# MY1 (2022) MONITORING REPORT

## PHANTOM MILL

**Response to DMS Comments – MY 1 (2022) Report**

Phantom Mill Mitigation Site – Alamance County

# Figure D1: Phantom Mill 30-70 Percentile Graph for Rainfall

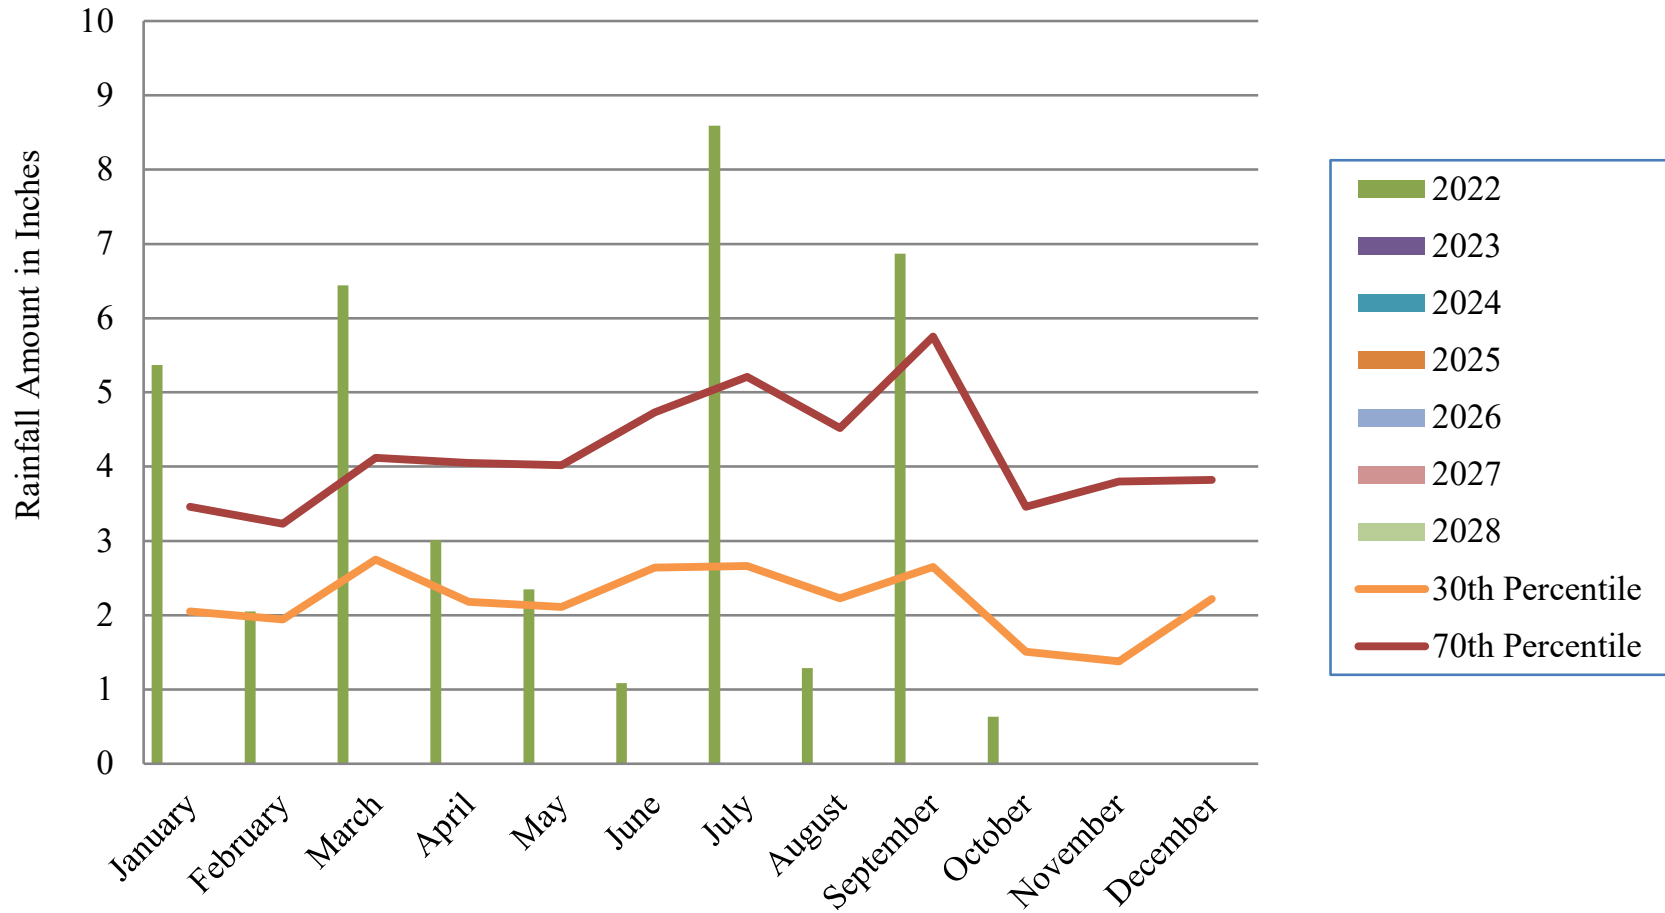
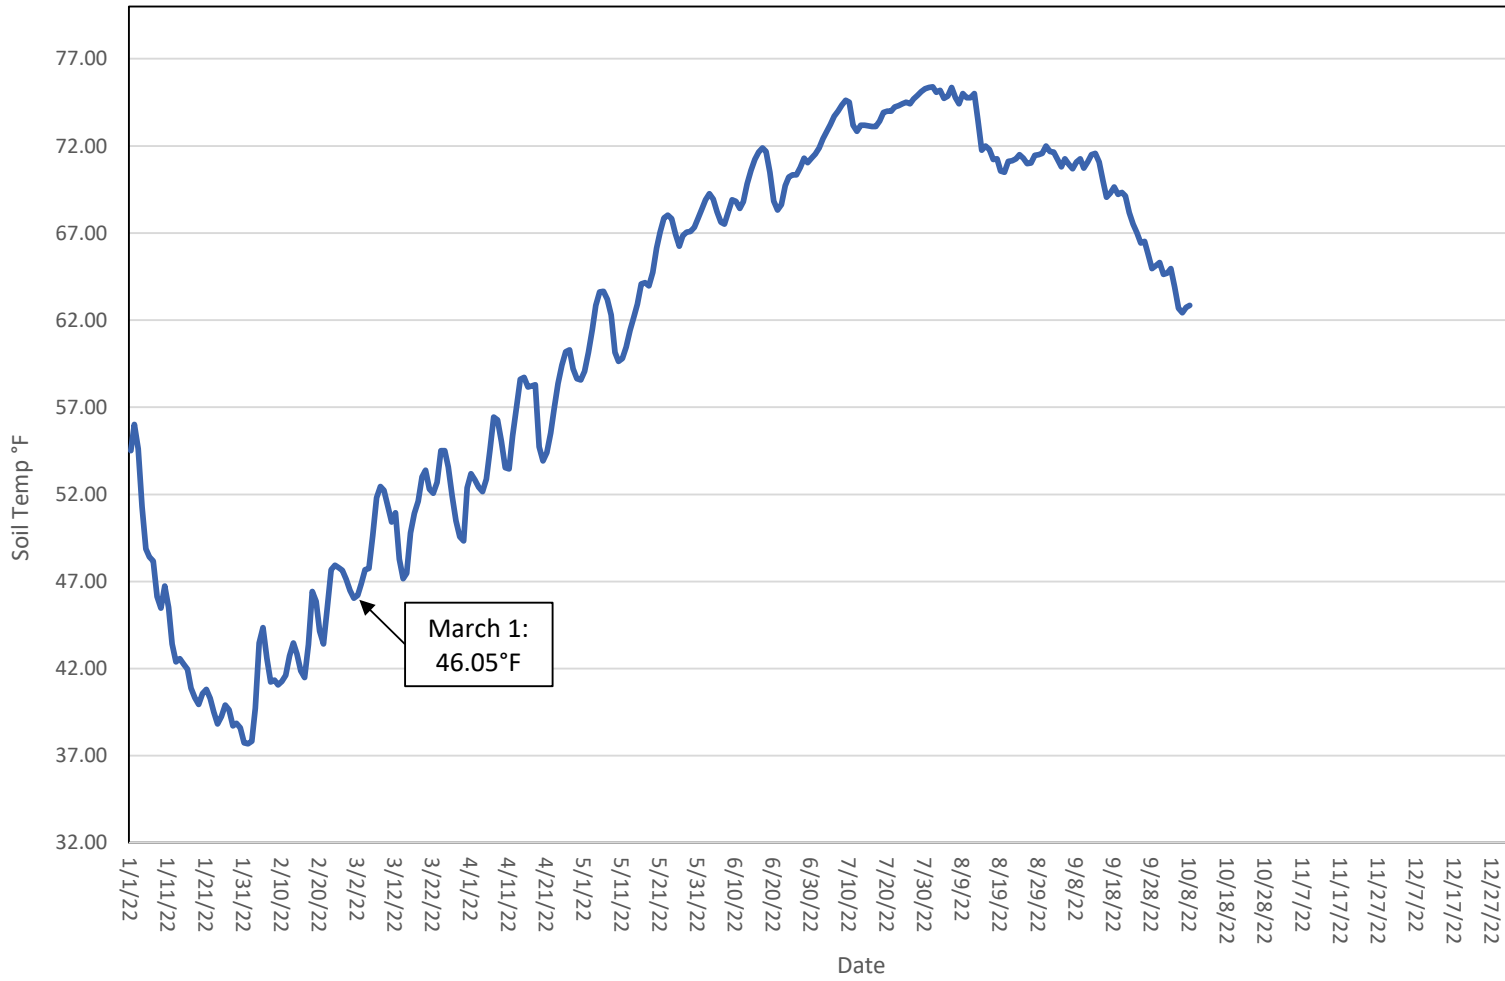
4. Figure D1 Rainfall: For all future reports please provide a full year of rainfall data. Capturing data from the end of the previous monitoring year through the current monitoring year. Ex: Nov 2021-Oct 2022.  
[Response: All rainfall data will be provided on Figure D1 for future reports, up to the point of submittal.](#)
